**NOTICE OF A TYPE II DECISION ON A PROPOSAL IN YOUR NEIGHBORHOOD**

**CASE FILE NUMBER: LU 09-123234 CU HDZM**  
**CEDARWOOD SCHOOL ANNEX/PARKING COURT**

**Case Type:** **CU HDZM** (Concurrent Conditional Use and Historic Design Review, with Modifications through Historic Design Review)

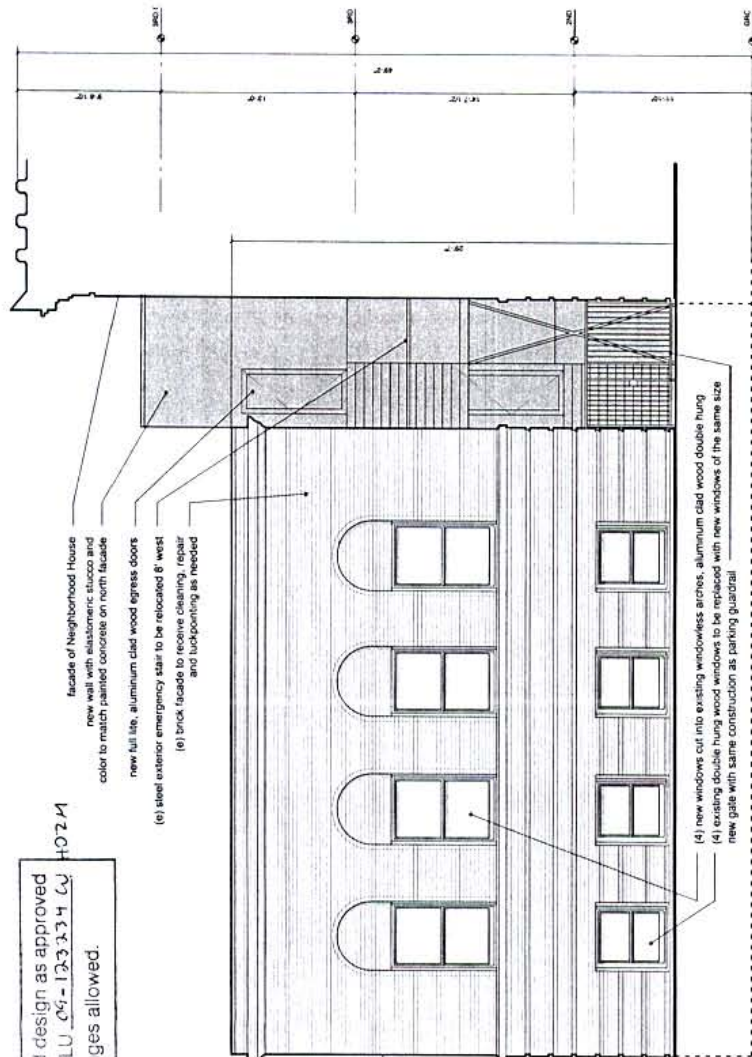
**PER CONDITION B:**  
 RE-PLANT LAWN OR  
 GRASS COVER THESE  
 TWO AREAS

**PER CONDITION B:**  
 RE-PLANT MAINTAIN  
 GRASS PLANTING  
 STRIPS ALONG SIDEWALKS  
 AS SHOWN

- B. (CU and HDZ) The applicant must install all landscaping as identified on the landscape/site plan and via staff notes on the plan, including re-planting of the denuded sandbox/play area immediately west of the annex, and restoration of groundcover or lawn in the planting strips straddling the public sidewalks in SE Second Avenue and SW Porter Street.
